Thank you for contacting the City of Sammamish regarding the current Shoreline Substantial Development Permit Application for East Lake Sammamish Trail Segment 2B (SSDP2016-00415).

**Exhibit 29**  
**SSDP2016-00415**  
**004983**

Regarding: East Lake Sammamish Trail - South Sammamish Segment B 60% Design Plan

NARROW TRAIL THROUGH THE NEIGHBORHOOD  
18' WILL ELIMINATE PARKING

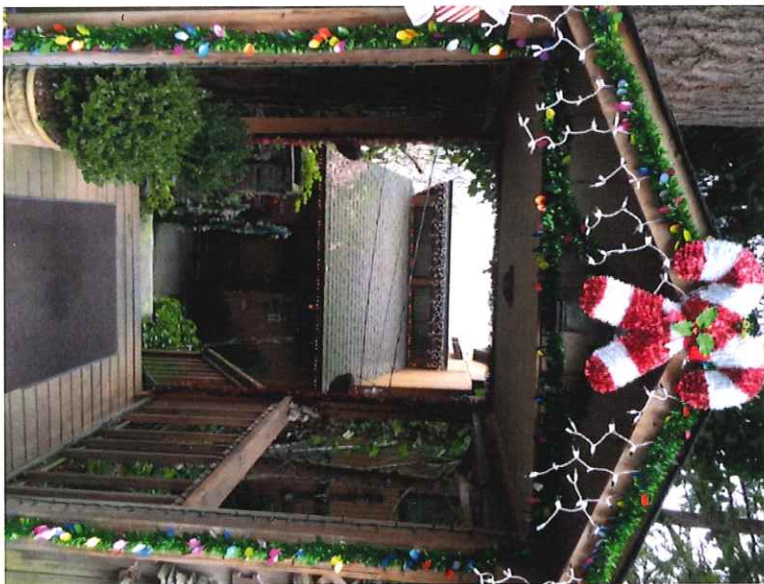
PROBLEM #1--TRAIL WIDTH: The 60% Plan, as presented by King County, calls for an 12 foot wide, paved trail to be routed through our neighborhood--with an added six (6) feet for soft shoulders and "cleared space". The 12 foot trail will cause several problems for the homeowners, with some listed below, but the main one deals with parking. The 60% Plan calls for parking spaces to be eliminated--which in turn will create havoc for others. Homeowners and their guests will now be forced to park their vehicles on East Lake Sammamish Parkway, which will greatly affect traffic flow and completely block the designated bike lane. That will be a major safety problem. With traffic moving at 40 mph, people of all ages will be getting in and out of vehicles, and in warmer weather and weekends will be carrying coolers, kayaks, floaters and picnic

Photo 2

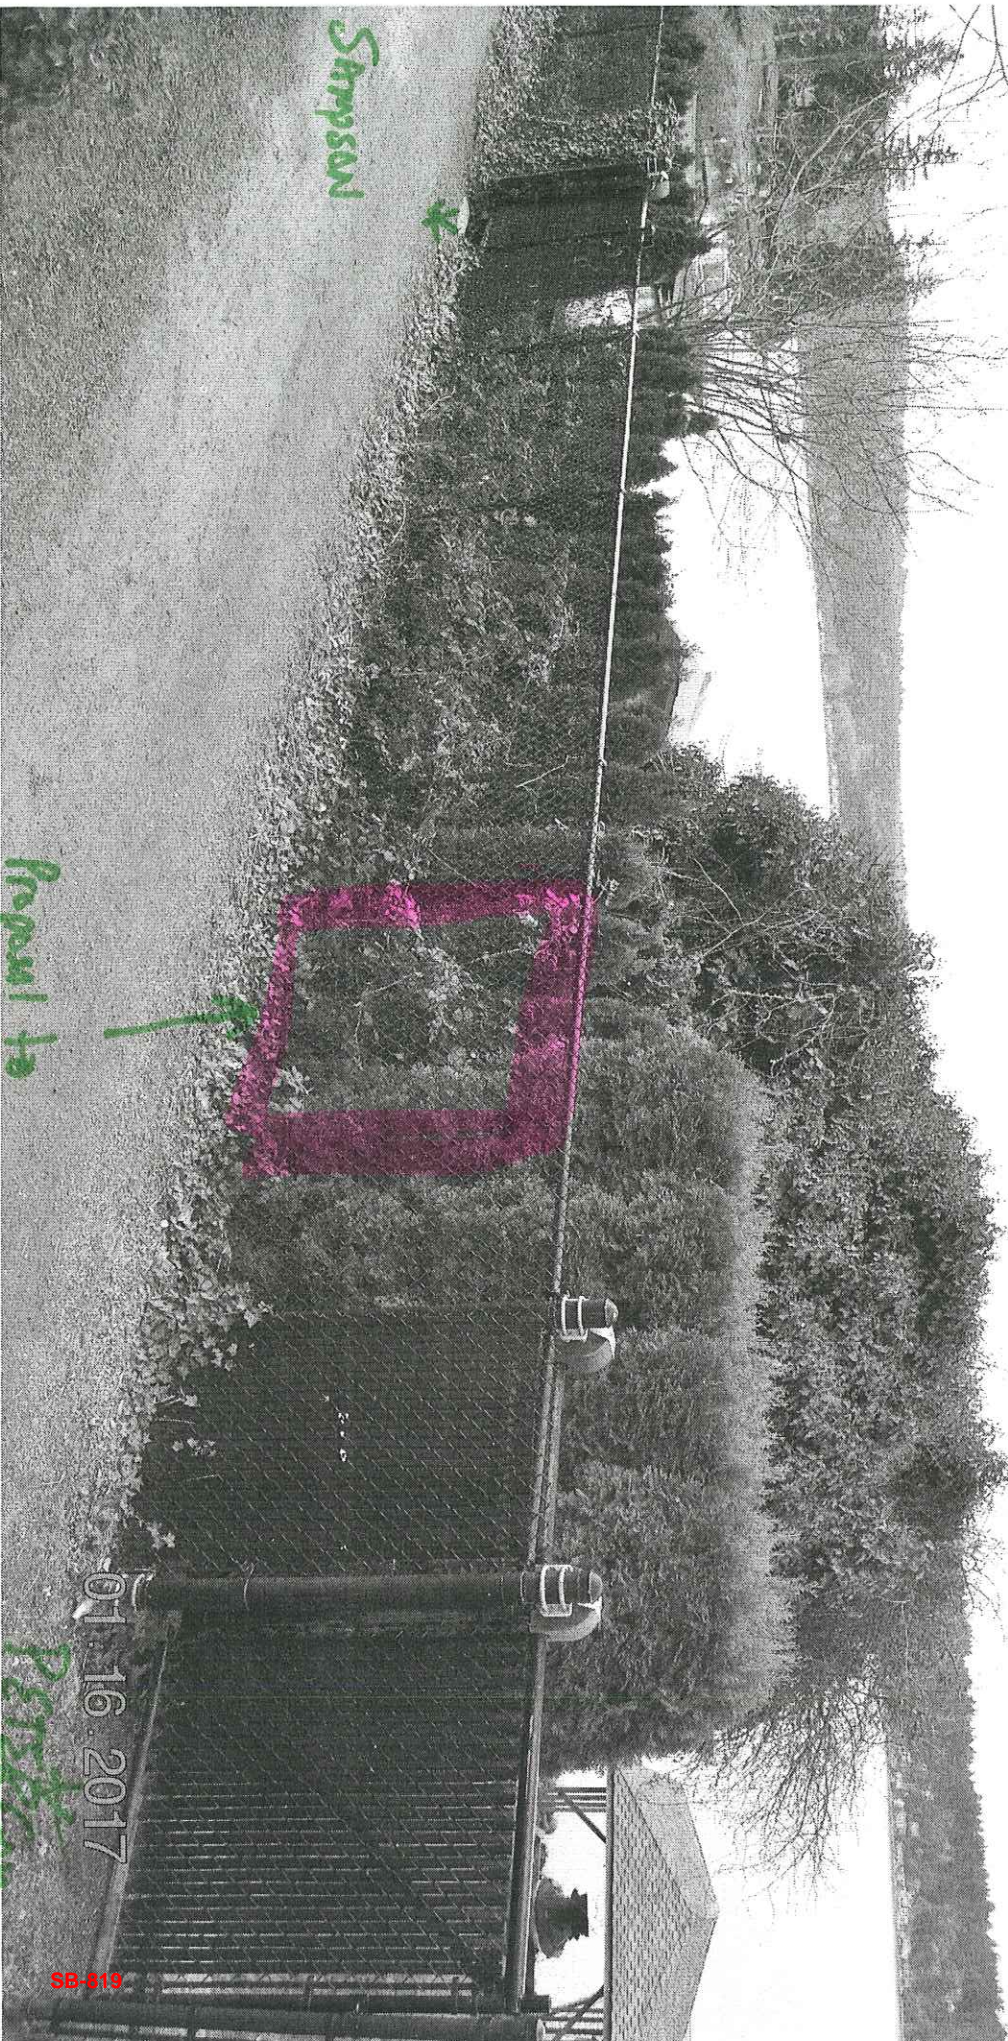
c. The access gate for us in the submitted plan, would require us to traverse the complete width of our property on the trail and to cross the trail to gain access to the lake side portion of our property. (See photos 2,4, Fig 1 delineated in pink). Therefore, the location, orientation and design of the access gate as submitted would create a significant physical barrier, safety concerns, and would place undue hardship on us, the residents.

Proposed to  
Relocate Access

Photo 3

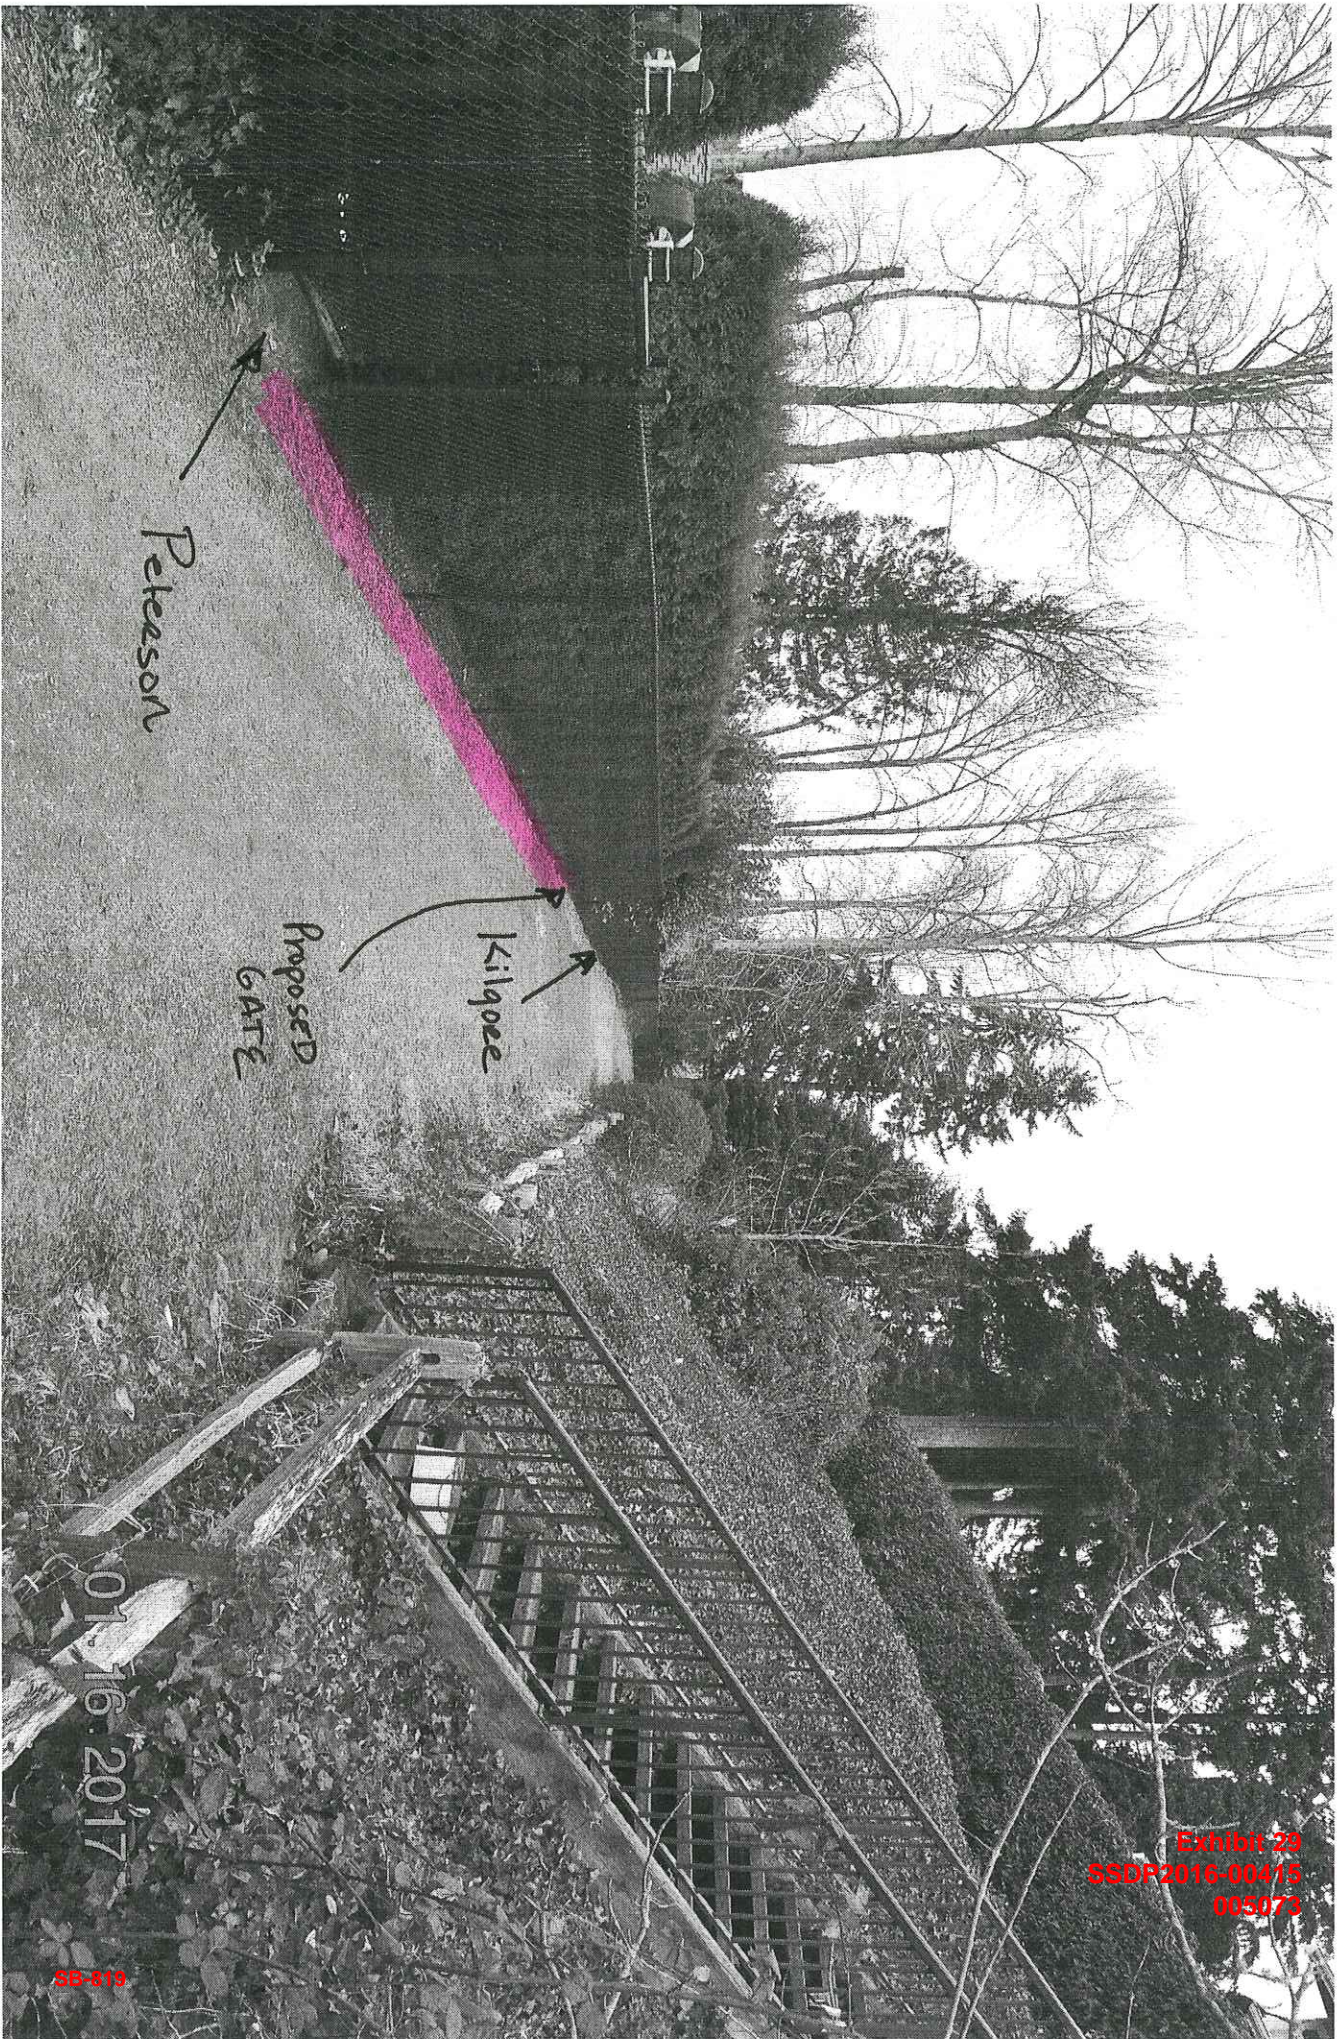
- This location will provide a better crossing point to the respective properties. (See photo 3, fig 2 delineated in red.
- An access gate at this property line would be much closer to the stairs coming down from both residences.

Fig # 1

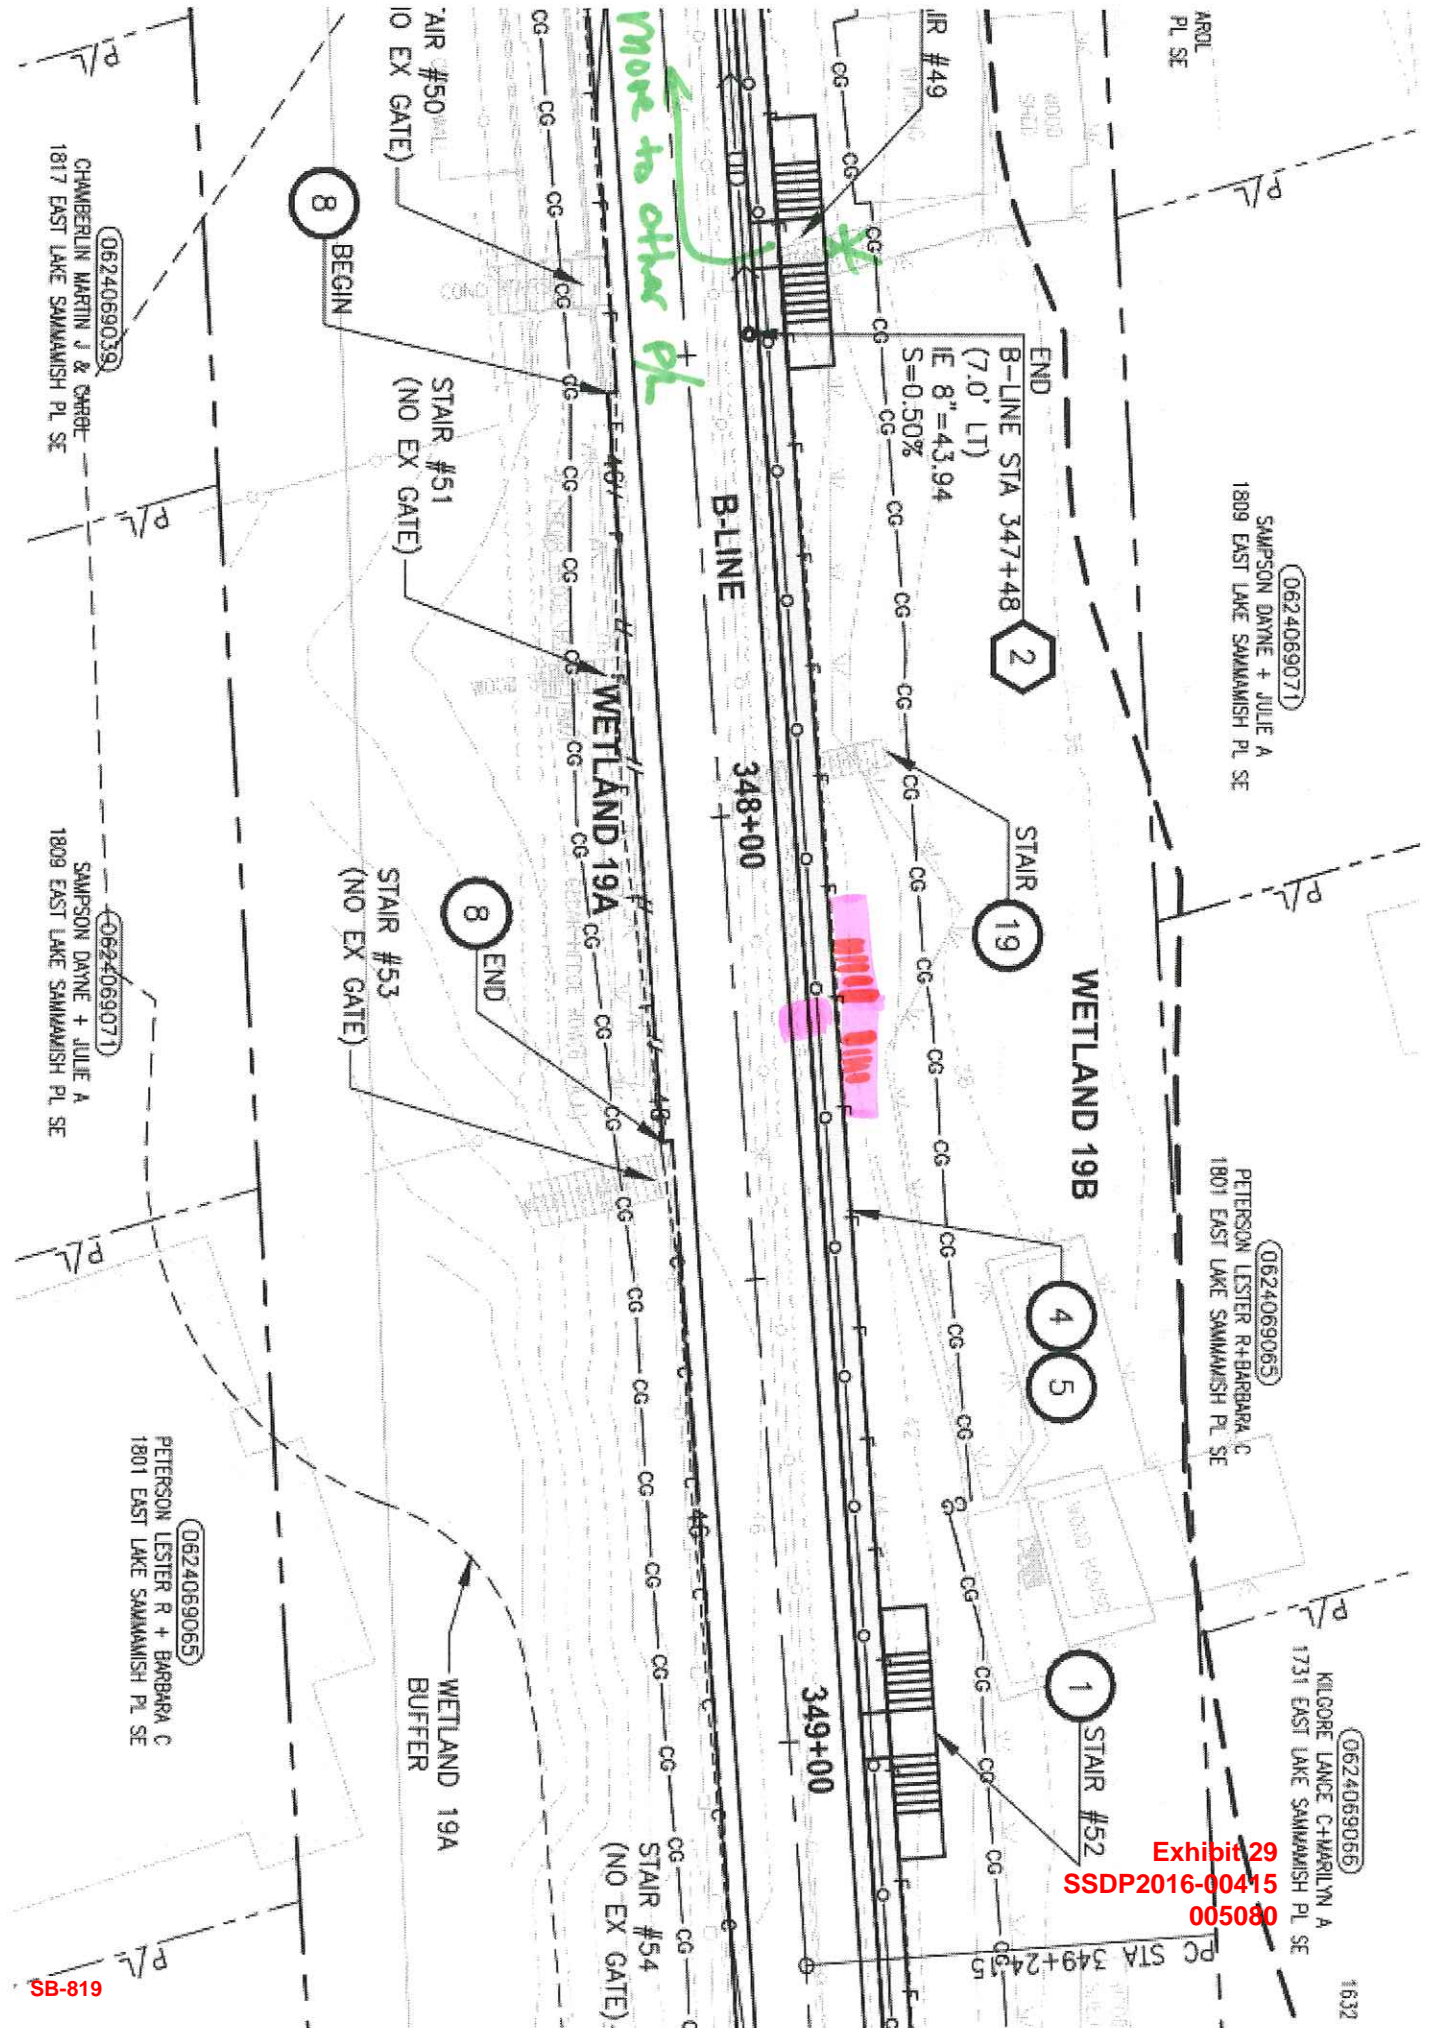
- a) Page EX 9 (Existing Conditions Plan)
  - Wetland mapping is inaccurate for our parcel, as submitted on the plan . (See photo 6,7 Fig 1 delineated in yellow). The area highlighted is inaccurate as to its dimensions and location. This area, the is lawn elevated 3 feet by a concrete retaining wall and planting bed.
  - Stairs on the lake side of trail are omitted on the plan submitted. (See photo 6,7 delineated in red). Currently there are stairs which negotiate the steep slope from the interim trail to our lawn.
- b) Page AL 14 (Plan Profile)
  - Wetland mapping is inaccurate for our parcel, as submitted on the plan. See above.
  - Existing stairs on lake side are omitted in plan that was submitted. See above.

- A portion (southern 3/4) of our concrete block retaining wall lies within the CG line. See photo 6,7. fig 1. delineated in green). This wall retains the hillside along the existing trail upland from our lawn. We would like the retaining wall to be preserved. If it is damaged, we would want it to be restored or replaced
- The location of the CG line appears to remove our existing wood stairs on the lake side of the trail ( missing on the current plan and mentioned above, A.2.b). Loss of these stairs would make access to the lake portion of the property unsafe. (See photo 6,7 delineated in red).
